## ADDENDUM

Project: Des Plaines Public Library Renovations Addendum No. **01**

Project No: 13300 Date: 02 September 2015

RFI #2

1 SECOND FLOOR FURNITURE PLAN  
 SCALE: 1/8" = 1'-0"

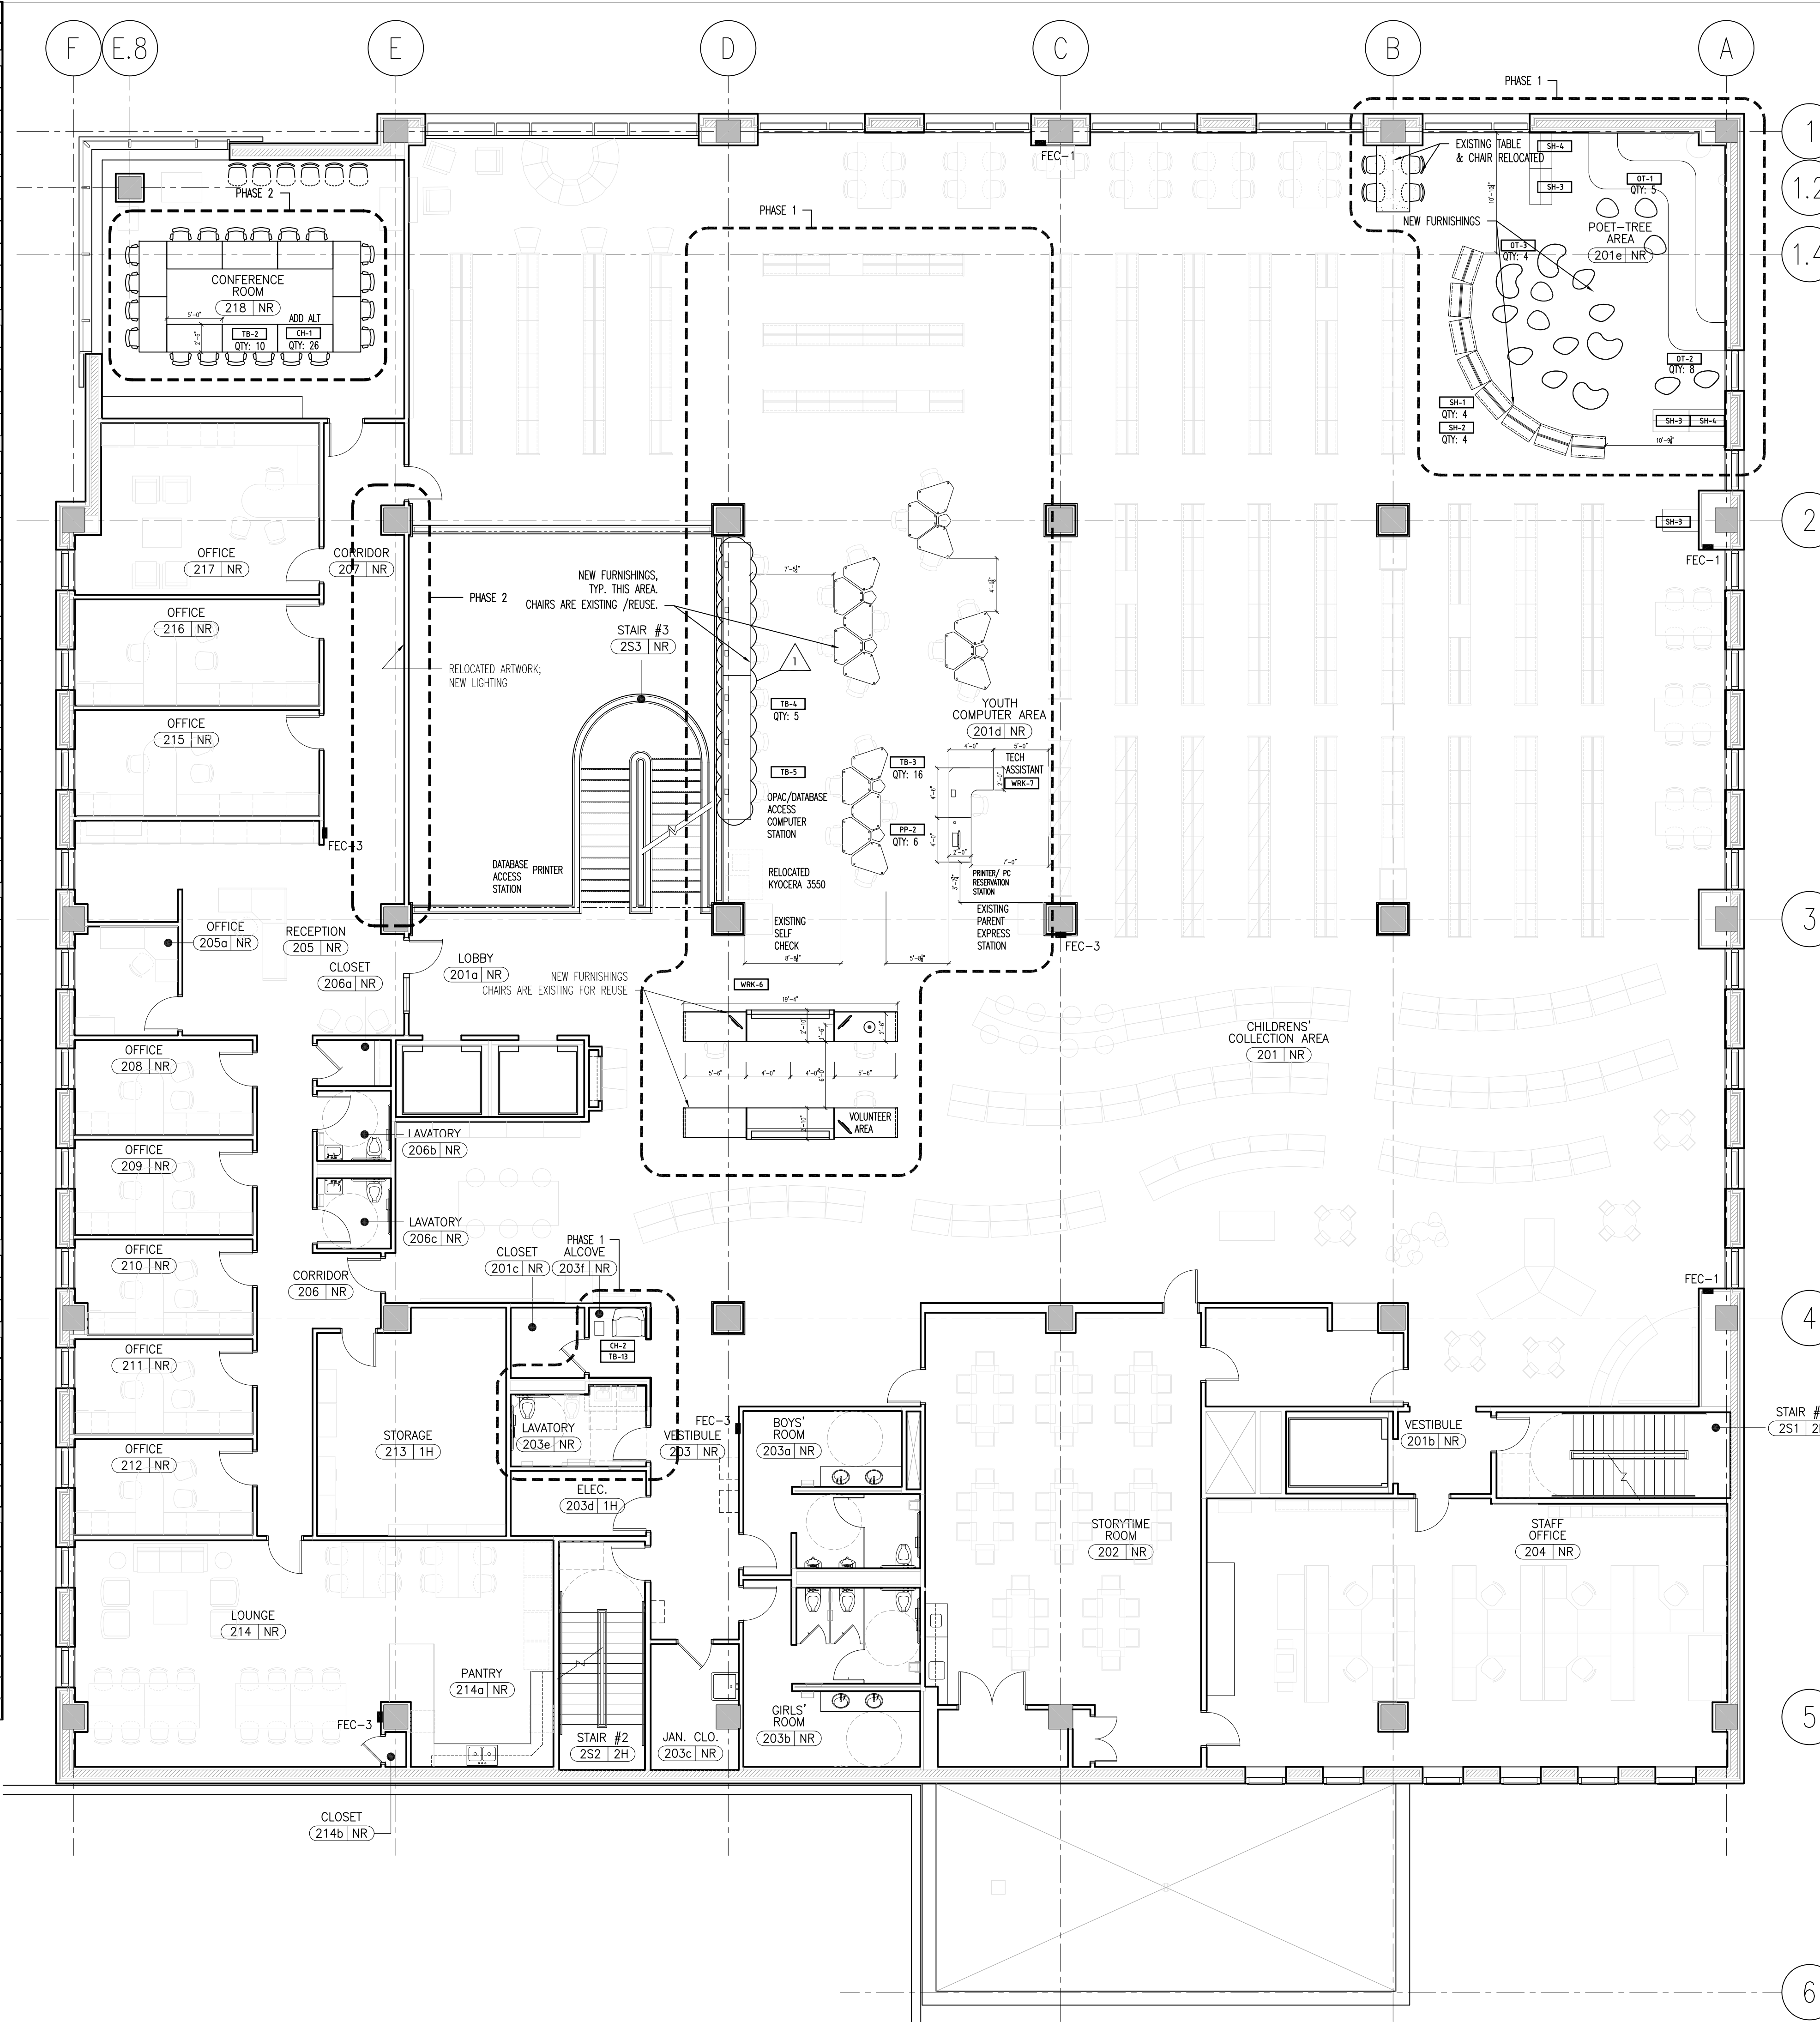
3. TB-4 and TB-5- Power and Data  
Do you want 1 Power/1 Data or something else?
  - **ONE POWER/ONE DATA PER TABLE AS PER THE ELECTRICAL PLANS**
  - **PLEASE NOTE, THE RECEPTACLES MUST BE TAMPER-RESISTANT. CODE SECTION 406.2 DEFINES A CHILDCARE FACILITY AS A LOCATION WHERE EDUCATION, SUPERVISION, OR PERSONAL CARE SERVICES ARE PROVIDED FOR MORE THAN FOUR CHILDREN UNDER THE AGE OF 7, THEREFORE THE CITY OF DESPLAINES WILL REQUIRE US TO PROVIDE THIS IN THIS AREA.**
  - **PLEASE NOTE TB-4 IS NOW 12'-0"W WITH A QUANTITY OF (1). TB-5 IS NOW 13'-0"W. SEE THE ATTACHED 2<sup>ND</sup> FLOOR FURNITURE PLAN REVISION & SPECIFICATION SECTION.**
